**TRAFFIC IMPACT STUDY**

**PROPOSED BLACK HILLS CENTER**

**RAPID CITY, SOUTH DAKOTA**

**REVISED OCTOBER 2010**

Figure 5: Dan Christy Lane Existing Traffic Volumes

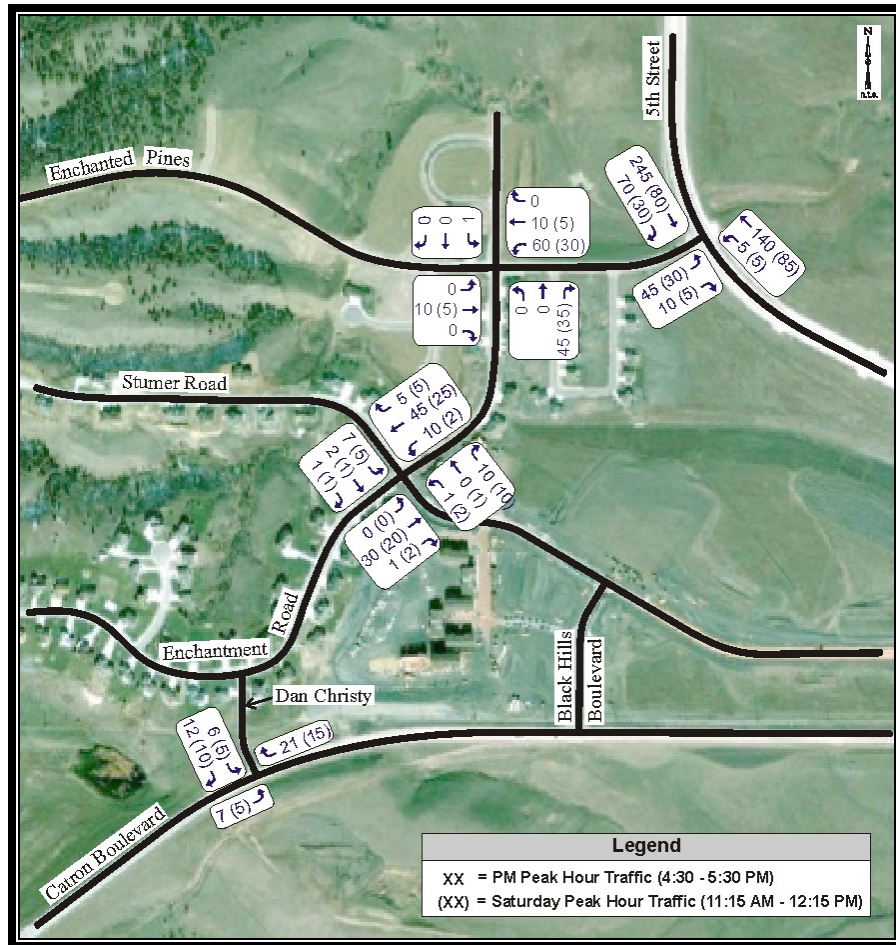
After further data collection, i.e. traffic counts at the intersection of Catron and Dan Christy and vehicle tracing through the subdivision, there is not a current cut-thru issue of motorists traveling through the subdivision to bypass the intersection of Catron and 5<sup>th</sup> Street. Thus, all text in the preliminary TIS was removed with regards to Dan Christy being used as a cut-thru route. We will remove this section from the report and revise the analysis accordingly. The minimal left-turn movements at Dan Christy (shown in Fig 5 in the TIS) were reassigned to Black Hills Boulevard.

As part of the April 2010 revised Traffic Impact Study, actual traffic counts were collected at Catron Boulevard and Dan Christy Lane (reflected in Figure 5 of the Traffic Impact Study) which were less than those assumed for the March 2010 study. Furthermore, based on observations and vehicle tracings through the residential development, there was no observed cut-thru traffic utilizing Dan Christy Lane to Enchantment Road to Enchanted Pines to bypass the signal at Catron Boulevard

**Exhibit 5: 2010 Build Traffic Volumes**

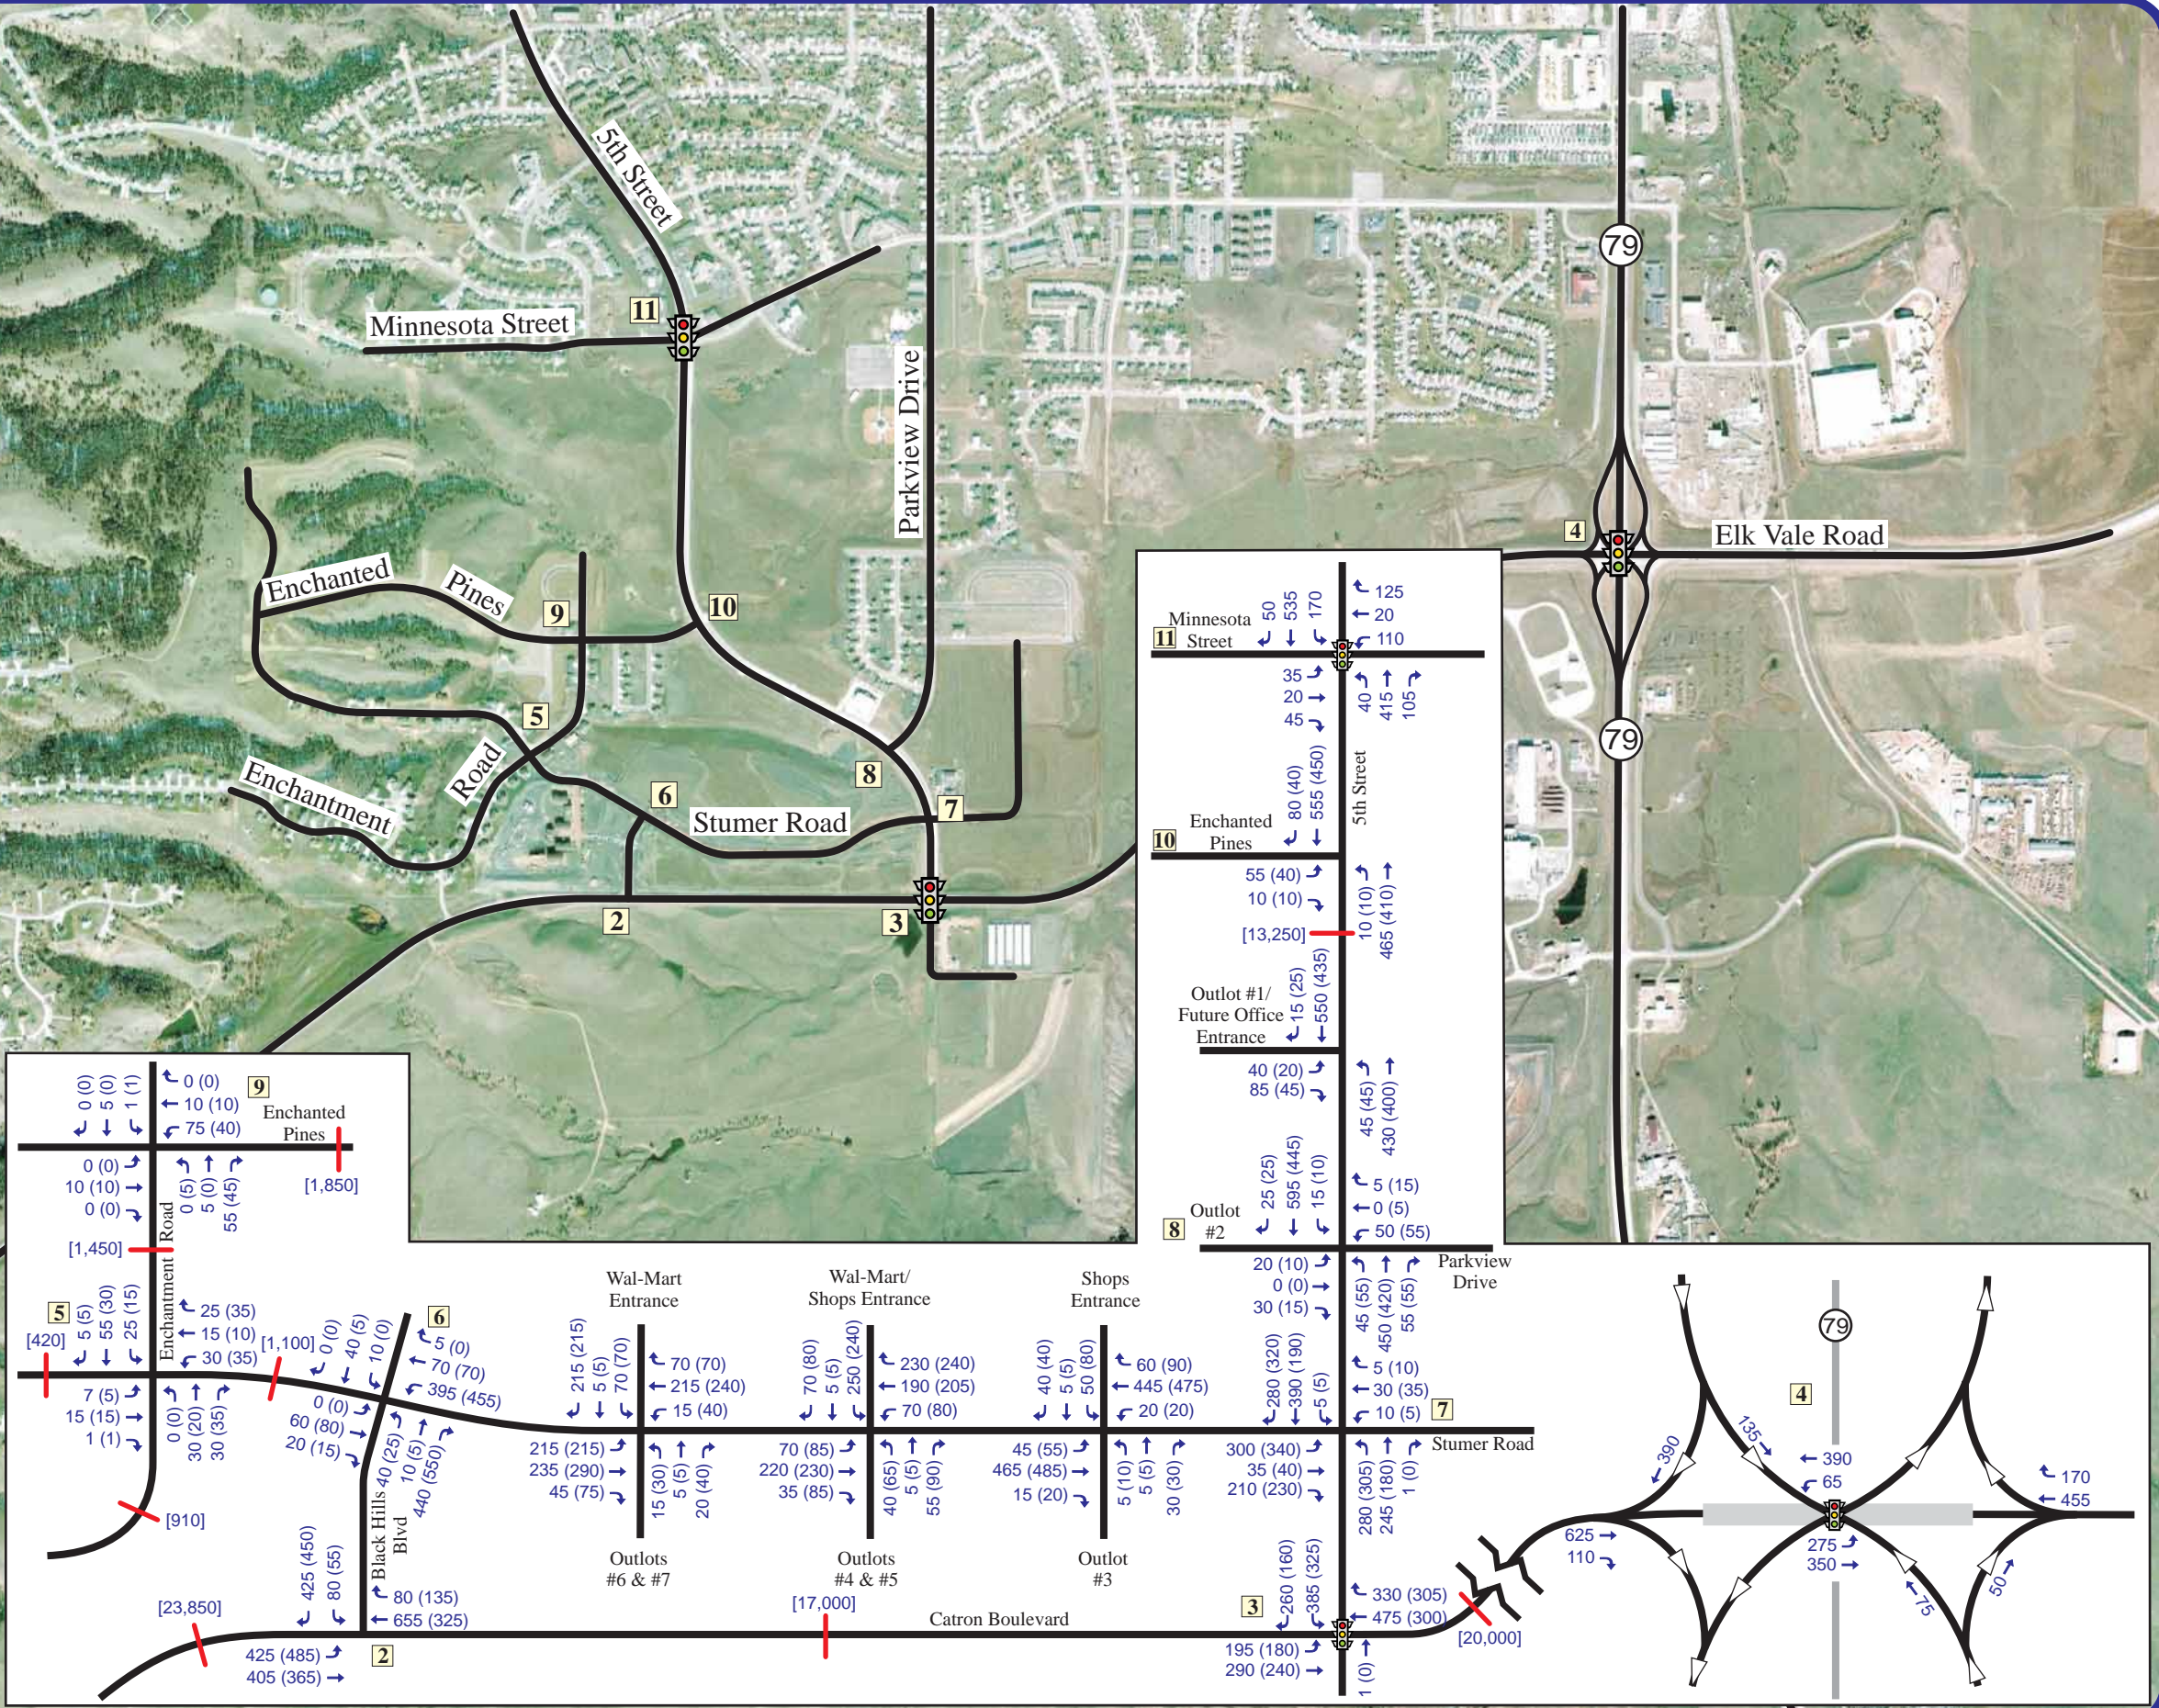
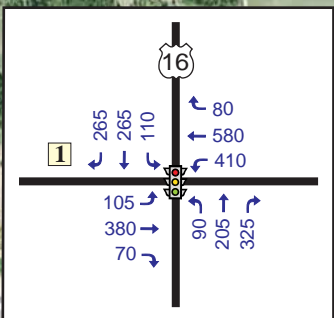
13. Exhibit 5 and Exhibit 7 – explain why the EB left turn lanes are less in 2030 than in 2010. See note for comment #11.
